DEMPSEY RESIDENCE POOL
606 BEDFORD ROAD, ROUTE 22
TOWN OF NORTH CASTLE
WESTCHESTER COUNTY, NEW YORK

TITLE: **SITE PLAN**

**Regarding: Dempsey Residence Pool
606 Bedford Road, Route 22
North Castle (T)**

This office has prepared an updated application which now includes items reflected in the RPRC Determination Letter dated February 16, 2021. The comments listed in the notice have been addressed as follows:

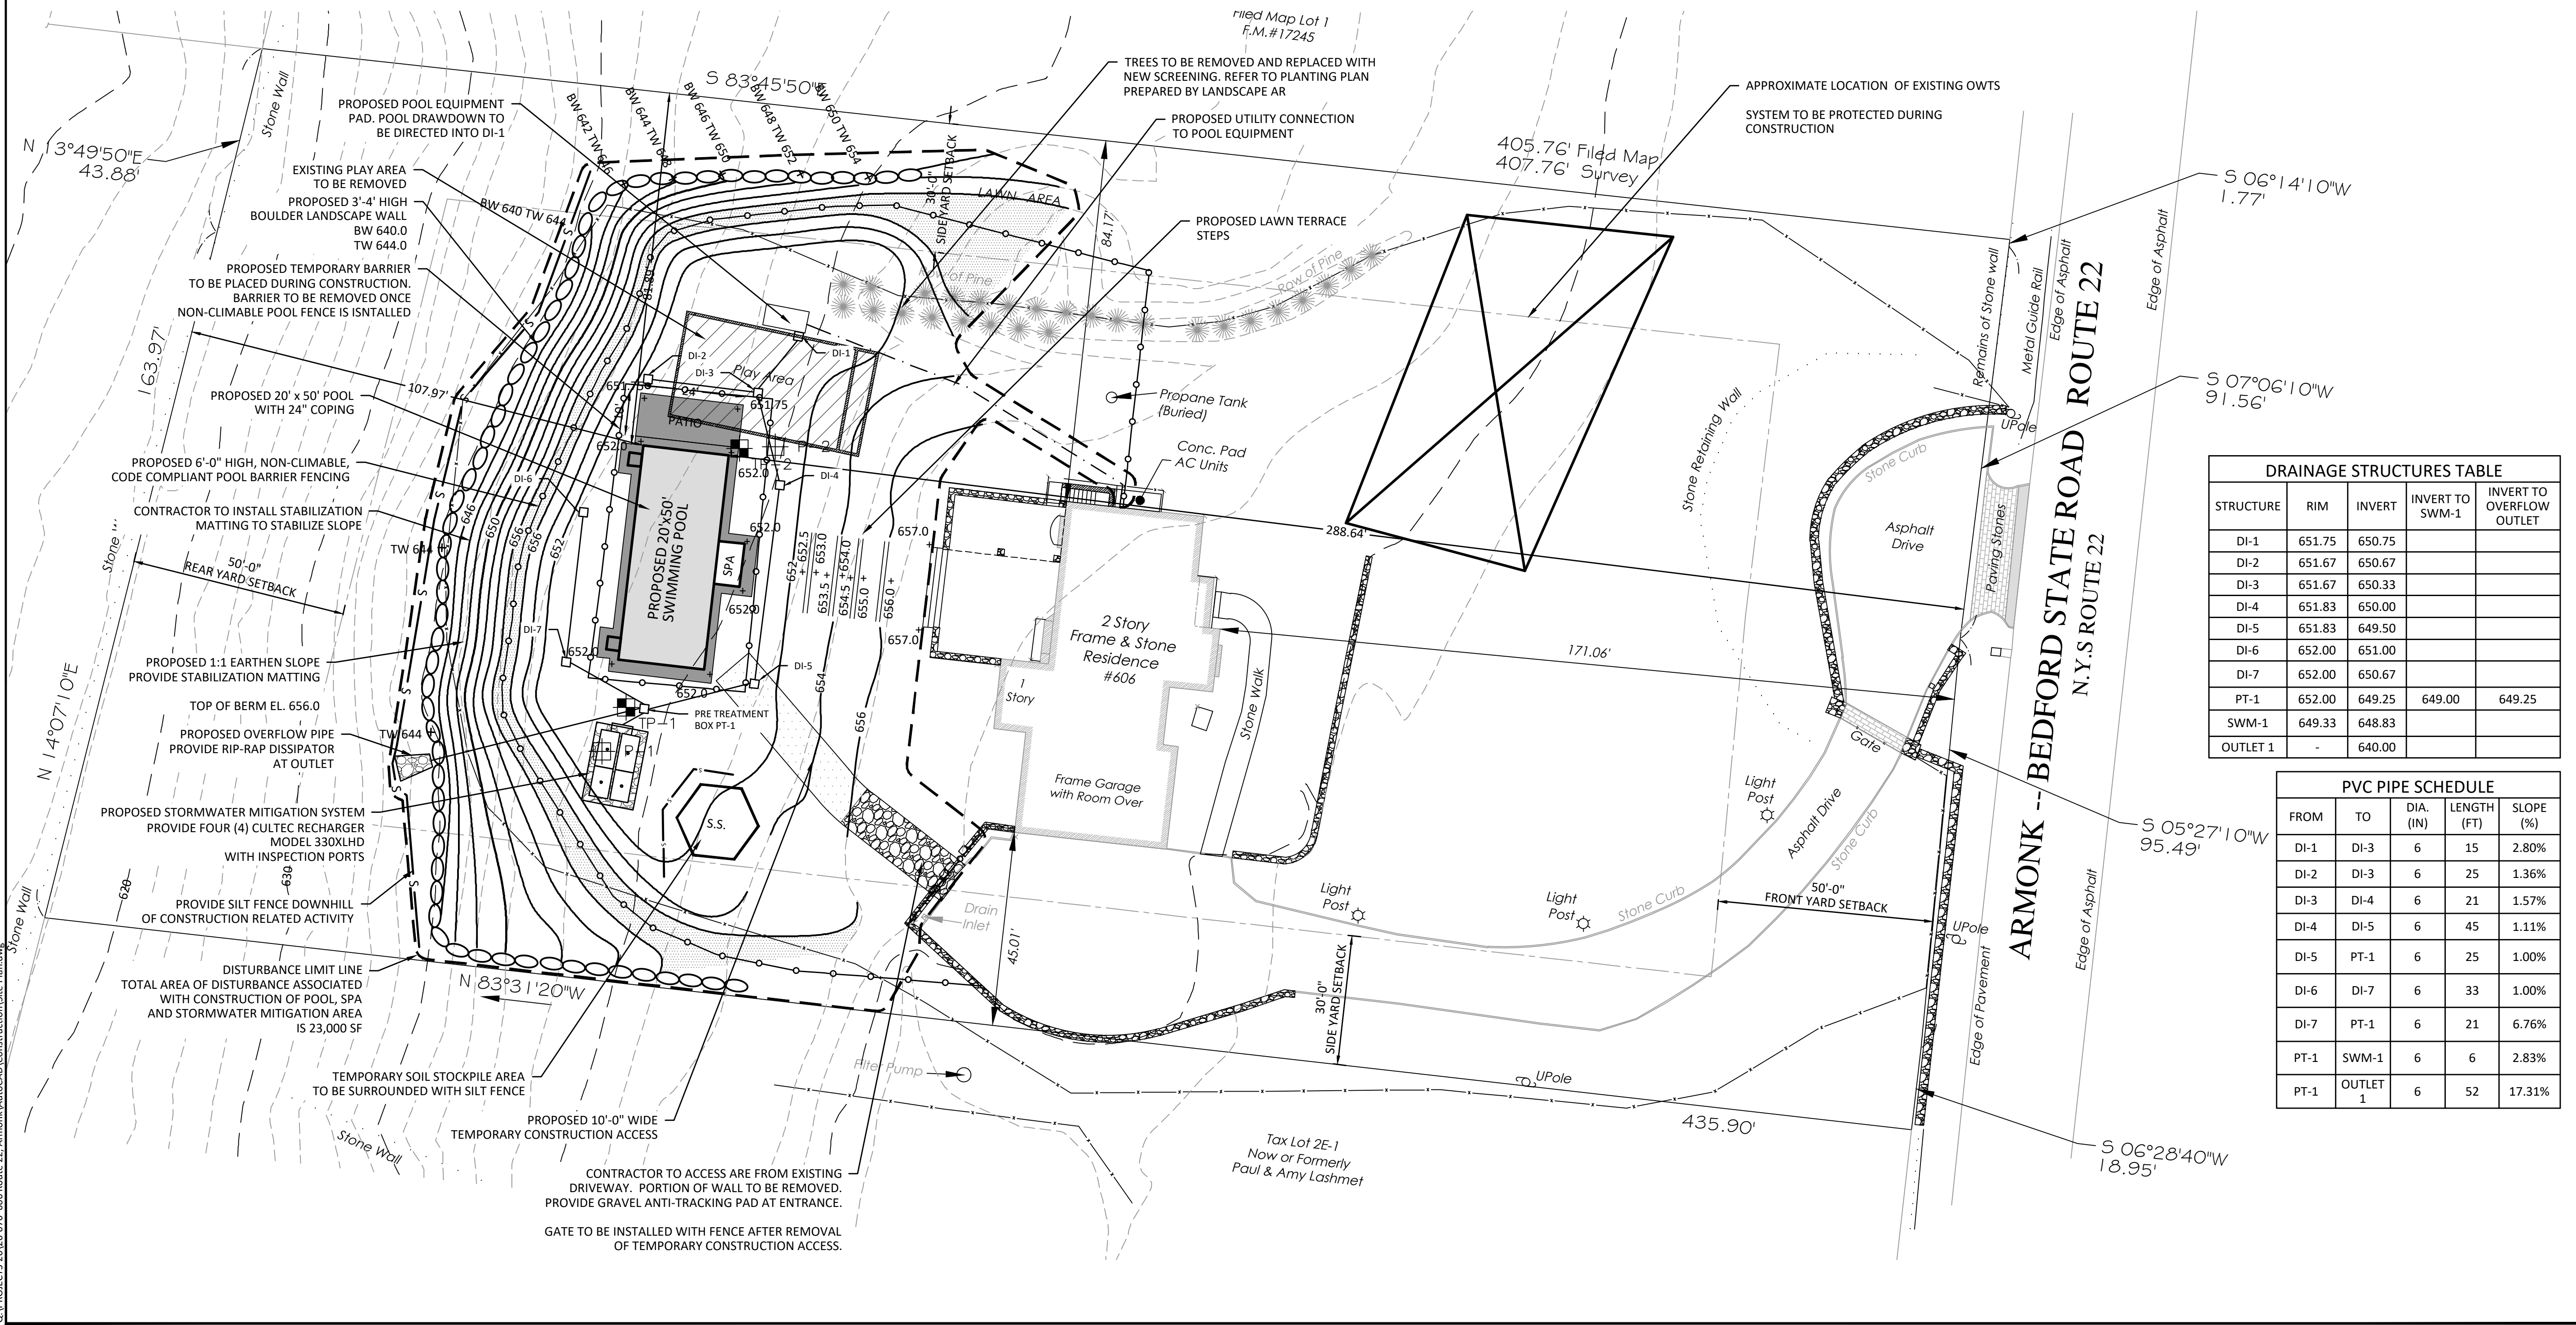
1. *The site plan should be revised to depict the type and size of proposed screening material.*

3. *The site plan does not depict any Town-regulated tree removal. A note should be added to the plan stating that Town-regulated tree removal is not proposed. If tree removal is required, further review by the RPRC is required.*

- 7. The applicant shall perform deep and percolation soil testing in the vicinity of the proposed mitigation system to be witnessed by the Town Engineer. The test locations and results shall be shown on the plan. Contact the Town Engineer to schedule the testing.*

- 9. Provide rims, inverts, size and material for all drainage facilities. Provide details.*

- 10. The plan shall include emergency overflow for the infiltration system to a stabilized outfall. Provide details.*

- 11. The plan shall illustrate the connection between the pool equipment and drawdown mitigation practice.*

Response: Plans have been updated to reflect an earthen berm with barrier fencing to replace landscaping along rear of pool area.

Response: A note has been added to the plan stating Town-regulated tree removal is not proposed. Evergreen trees impacted by site work will be replaced.

Response: Soil testing was conducted and witnessed by the Town Engineer on November 20, 2020. The test results have been provided.

Response: Drainage structure and pipe tables containing rims, inverts, sizes and materials have been added to the site plan. Details for the drainage facilities have been provided.

Response: An emergency overflow outlet to a stabilized outfall has been provided along with a rip-rap dissipator detail.

Response: Pool drawdown shall be directed into Drain Inlet 1 which will direct drawdown towards mitigation practice via drainage pipes.

LANDSCAPE BOULDER RETAINING WALL DETAIL
NOT TO SCALE

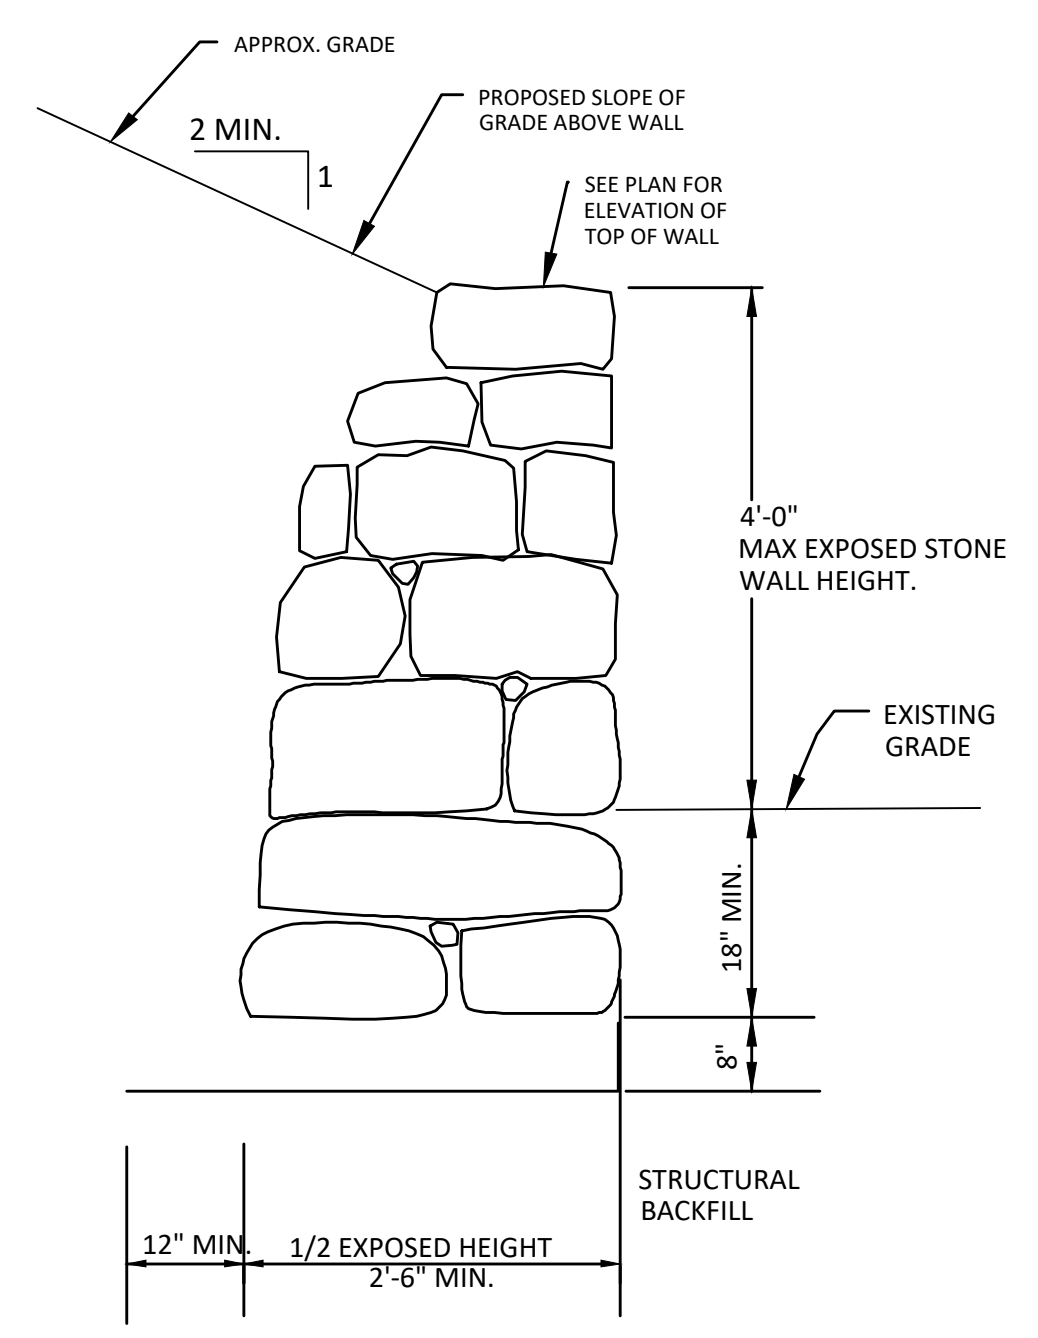
4. *The plan shall include a detail for the proposed retaining wall.*

5. *All walls greater than four (4) feet in height shall be designed by a NYS Licensed Professional Engineer. Provide construction details and specifications on the plan.*

Response: A detail for the proposed wall has been provided.

Response: The proposed wall shall be no greater than four feet in height. A detail for the wall has been provided.

POOL ENCLOSURE FENCE
NOT TO SCALE

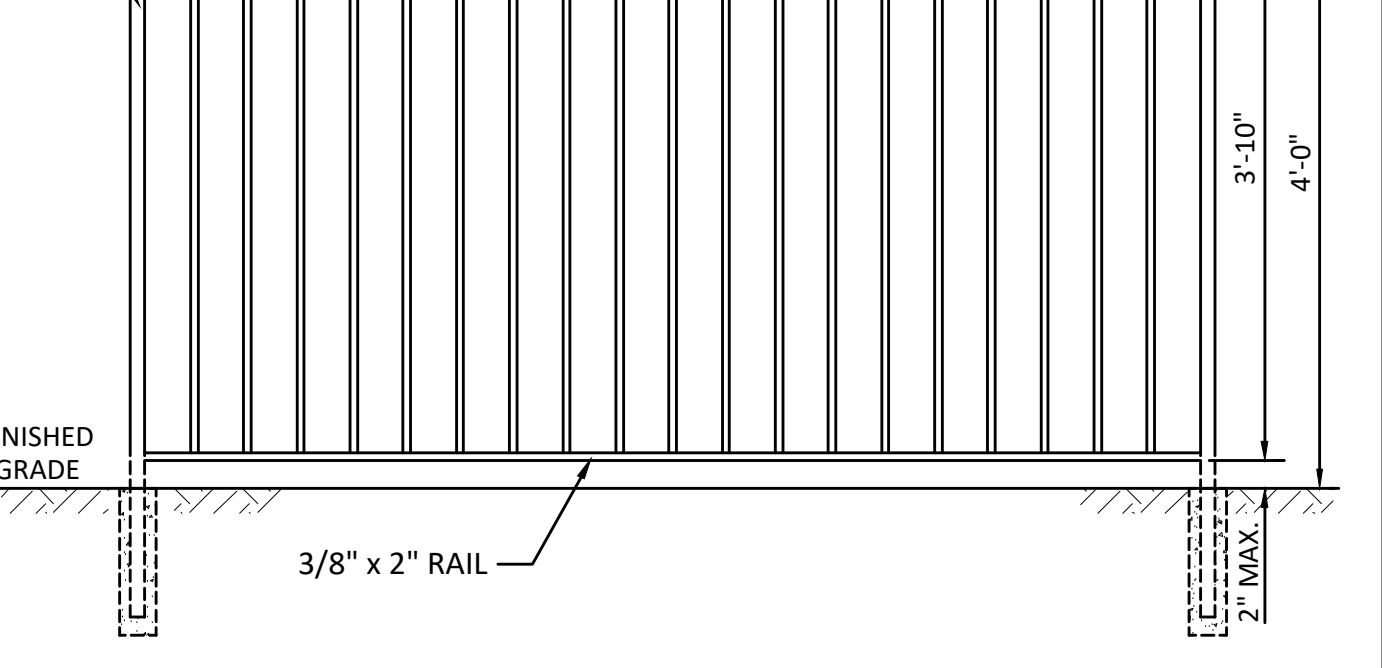
2. *The pool fence detail should include the proposed height of the fence.*

Response: A fence detail has been provided and includes the proposed height of the fence.
